**re: Grading & Site Servicing Plan Review**  
Proposed Multi-Storey Building  
1815 Montreal Road – Ottawa, Ontario

**file: PG6594-MEMO.02**

- Lot Grading, Drainage, Erosion & Sediment Control Plan – 9-Storey Apartment Building, 1815 Montreal Road – Project No. CCO-23-3469 – Drawing No. C101 – Revision 2 dated October 5, 2023.

- ❑ Site Servicing Plan – 9-Storey Apartment Building, 1815 Montreal Road – Project No. CCO-23-3469 – Drawing No. C102 - Revision 2 dated October 5, 2023.

# Figure 1 - Grading Plan Review

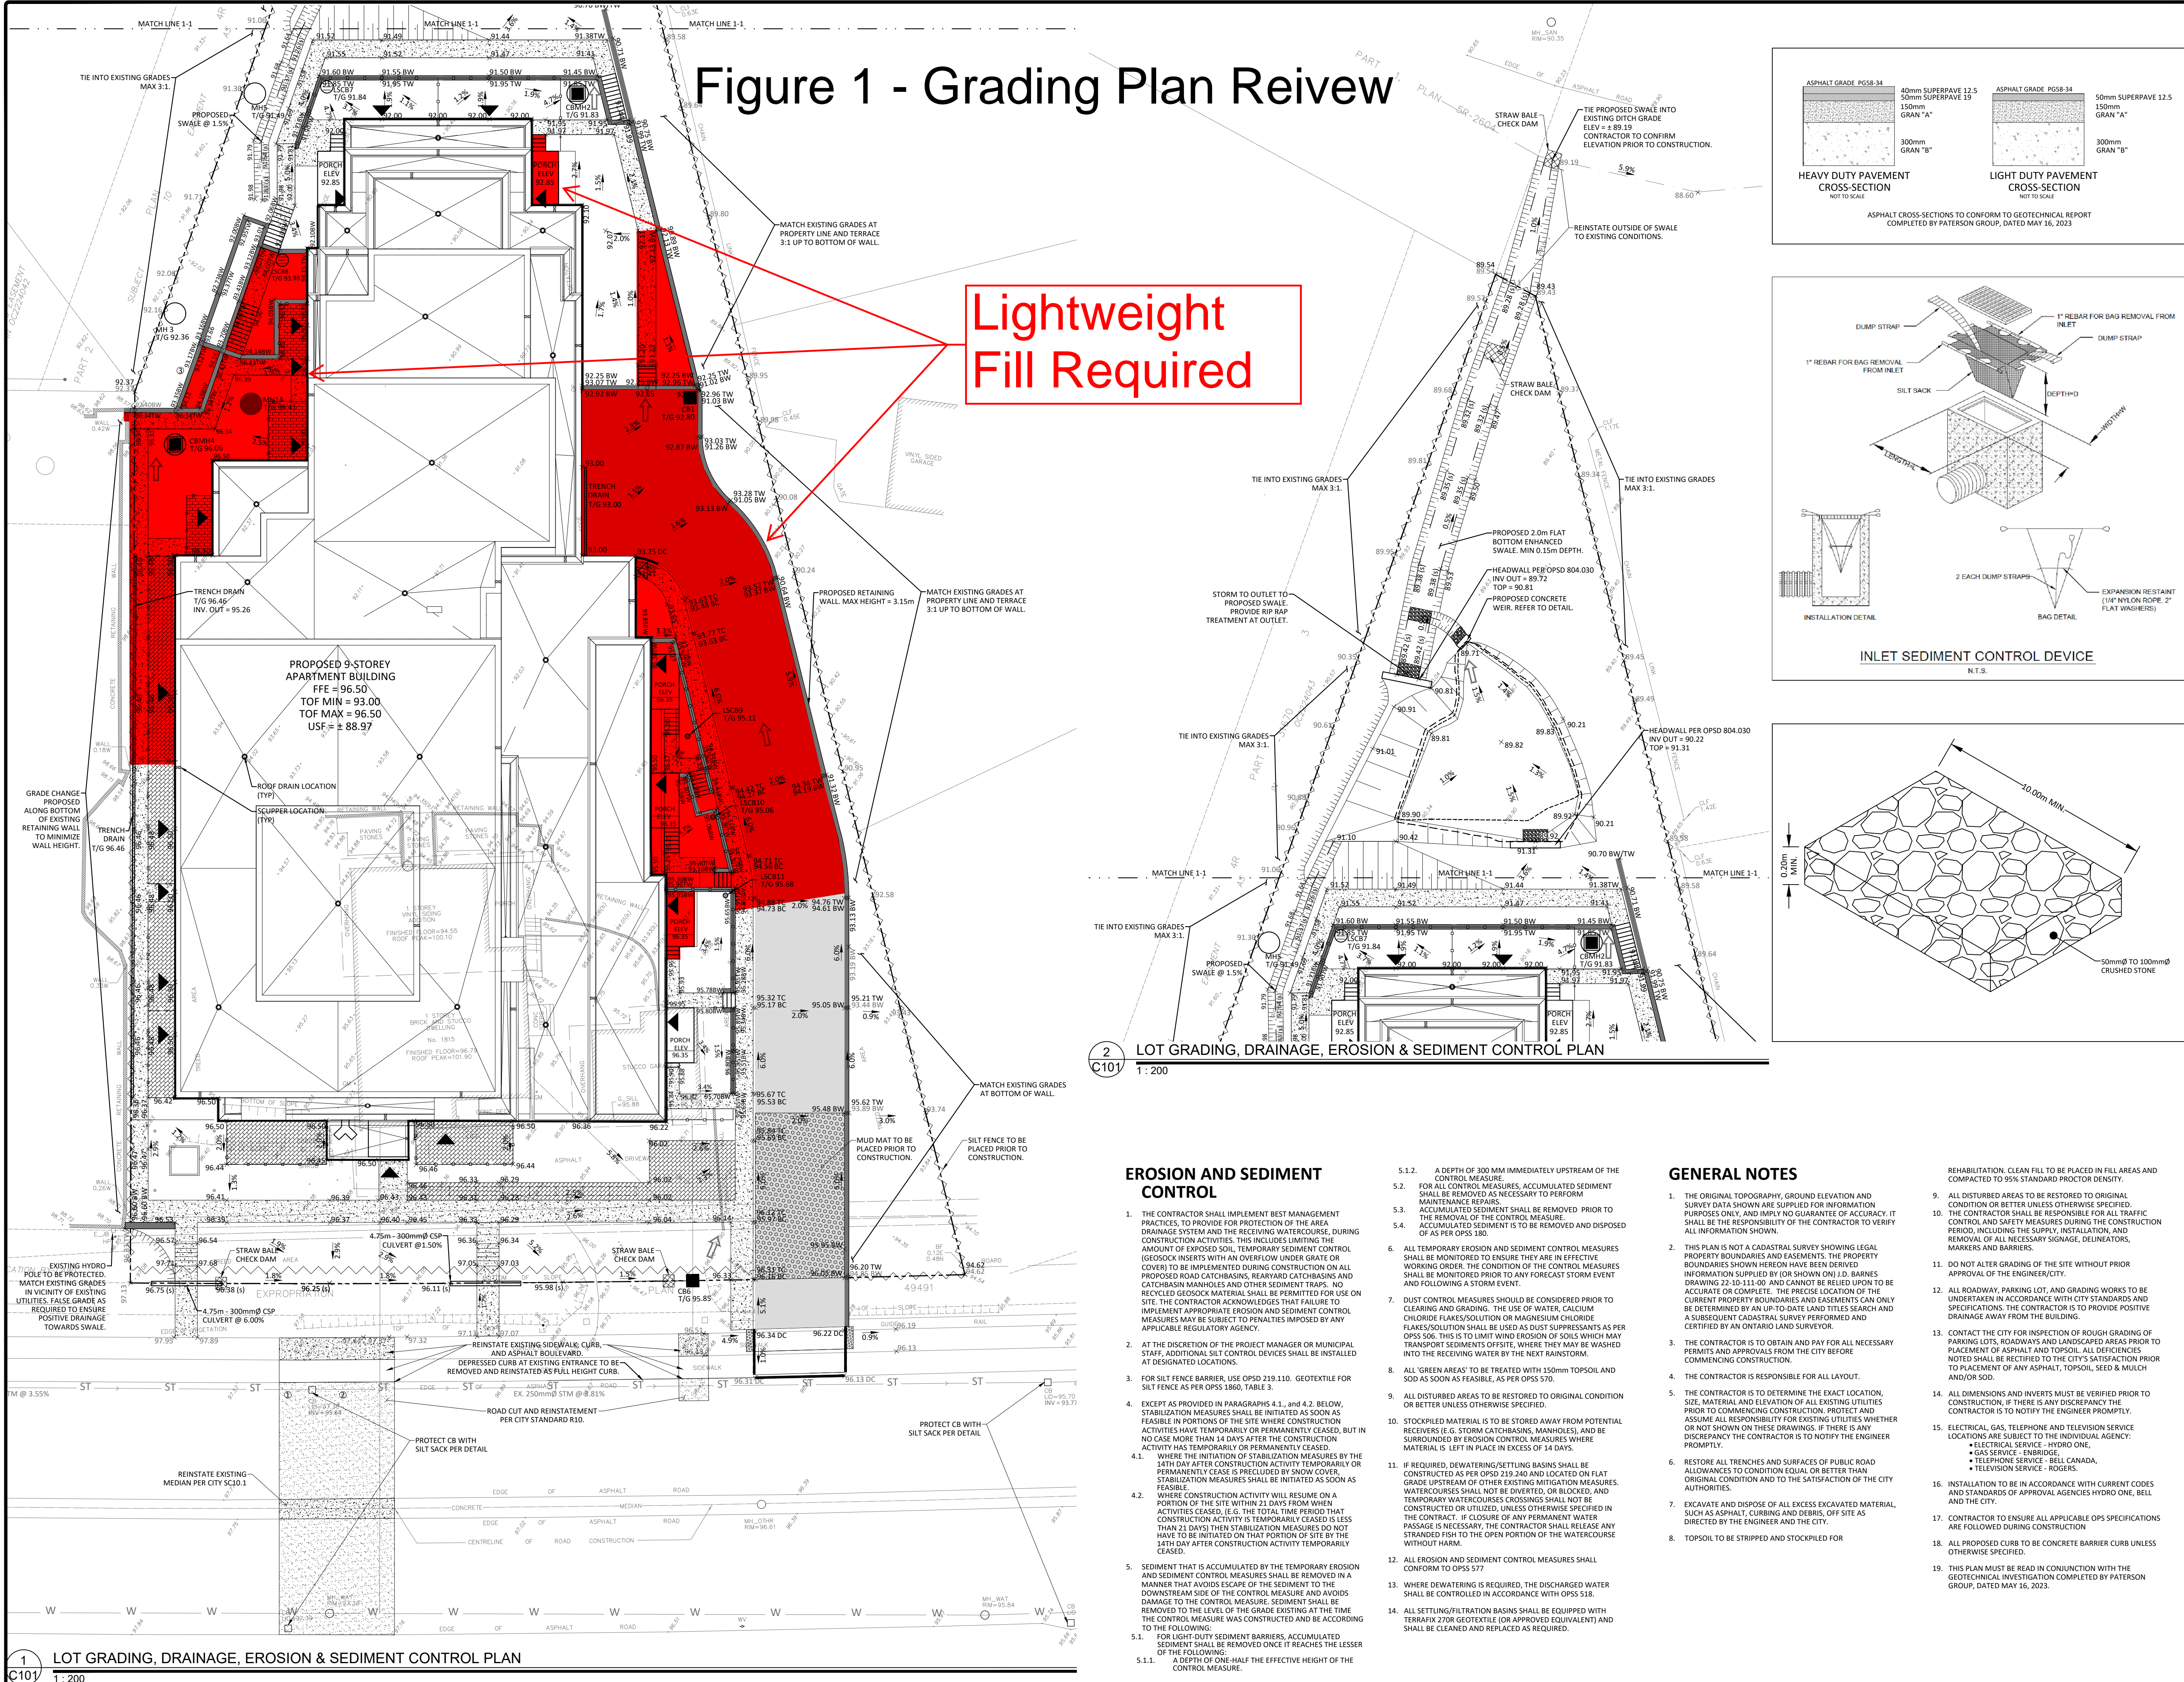
Due to the presence of the silty clay deposit at the site, a permissible grade raise restriction of 2 m was recommended for grading at the subject site. Based on our review of the grading plan, significant grade raise exceedances of approximately 2 to 2.5 m above the permissible grade raise restriction are proposed. As such, lightweight fill, such as expanded polystyrene (EPS) geofoam blocks, are recommended adjacent to the proposed building, retaining wall and other settlement structures, where grade raise exceedances are proposed, for the portion of the grade raise exceeding 2 m. Please refer to Figure 1 – Grading Plan Review, attached to the current memorandum, for the approximate limits of where lightweight fill (LWF) is required.

Lightweight  
Fill Required

# Figure 2 - Site Servicing Plan Review

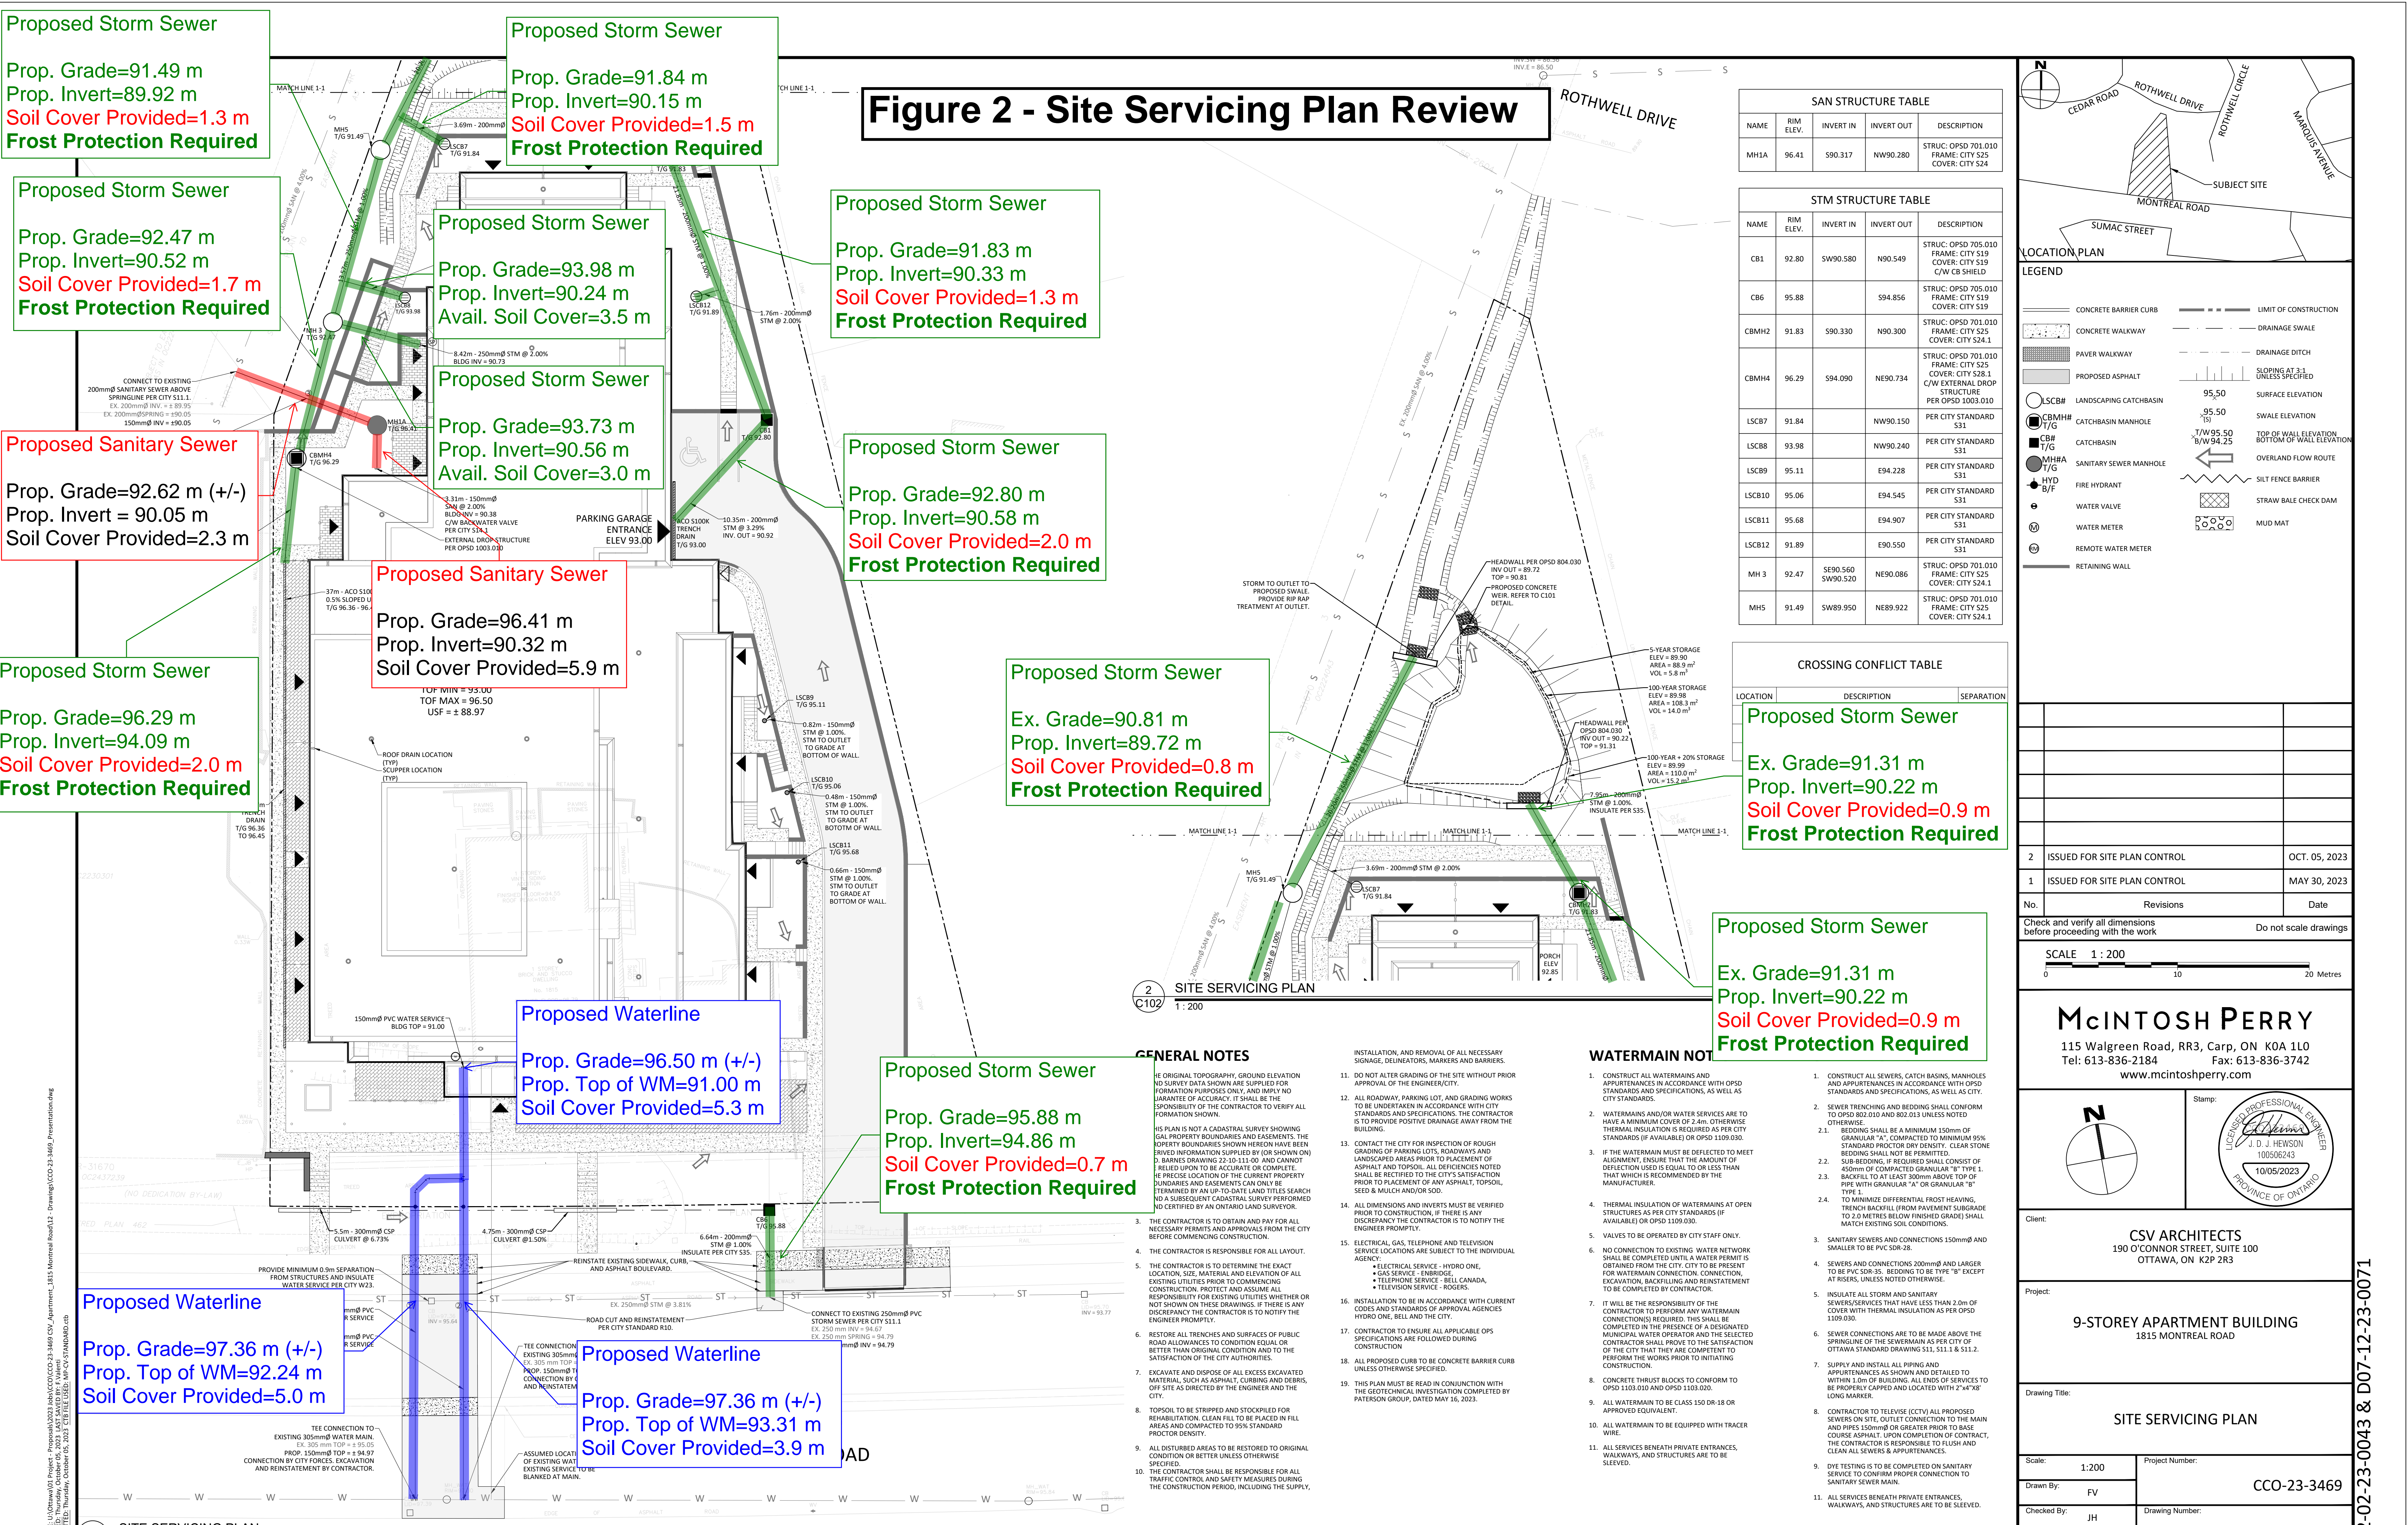
Based on our review of the site servicing plan, sufficient soil cover has been provided to the proposed watermain and sanitary services. However, insufficient soil cover was noted along segments of the proposed stormwater service. Where insufficient soil cover (i.e. less than 2.1 m of soil cover is present above the obvert of the pipe) is available, the following frost protection criteria outlined in Table 1 should be followed. Please refer to Figure 2 – Site Servicing Plan Review attached which indicates the frost protection provided to each service.

**Proposed Storm Sewer**  
 Prop. Grade=91.49 m  
 Prop. Invert=89.92 m  
 Soil Cover Provided=1.3 m  
 Frost Protection Required

**Proposed Storm Sewer**  
 Prop. Grade=91.84 m  
 Prop. Invert=90.15 m  
 Soil Cover Provided=1.5 m  
 Frost Protection Required

**Proposed Storm Sewer**  
 Prop. Grade=92.47 m  
 Prop. Invert=90.52 m  
 Soil Cover Provided=1.7 m  
 Frost Protection Required

**Proposed Storm Sewer**  
 Prop. Grade=91.83 m  
 Prop. Invert=90.33 m  
 Soil Cover Provided=1.3 m  
 Frost Protection Required

**Proposed Storm Sewer**  
 Prop. Grade=92.80 m  
 Prop. Invert=90.58 m  
 Soil Cover Provided=2.0 m  
 Frost Protection Required

**Proposed Storm Sewer**  
 Prop. Grade=96.29 m  
 Prop. Invert=94.09 m  
 Soil Cover Provided=2.0 m  
 Frost Protection Required

**Proposed Storm Sewer**  
 Ex. Grade=90.81 m  
 Prop. Invert=89.72 m  
 Soil Cover Provided=0.8 m  
 Frost Protection Required

**Proposed Storm Sewer**  
 Ex. Grade=91.31 m  
 Prop. Invert=90.22 m  
 Soil Cover Provided=0.9 m  
 Frost Protection Required

**Proposed Storm Sewer**  
 Prop. Grade=95.88 m  
 Prop. Invert=94.86 m  
 Soil Cover Provided=0.7 m  
 Frost Protection Required

<b>Table 1 - Rigid Insulation Recommendations for Storm Sewer and Water Pipes with Reduced Soil Cover</b>			
<b>Thermal Condition</b>	<b>Soil Cover Provided (mm)</b>	<b>Insulation Dimensions</b>	
		<b>Thickness (mm)</b>	<b>Extension (mm)</b>
Unheated	600 to 900	125	Extend 1200 mm horizontally beyond edge face of the pipe
	900 to 1200	100	Extend 1200 mm horizontally beyond edge face of the pipe
	1200 to 1500	75	Extend 900 mm horizontally beyond edge face of the pipe
	1500 to 1800	50	Extend 600 mm horizontally beyond edge face of the pipe
	1800 to <2100	25	Extend 300 mm horizontally beyond edge face of the pipe

All rigid insulation should consist of either Dow Chemical High-Load 40 (HI-40), Styro Rail SR.P400, or equivalent approved by Paterson. The placement of all insulation within the service trenches must be reviewed and approved by Paterson personnel at the time of construction.
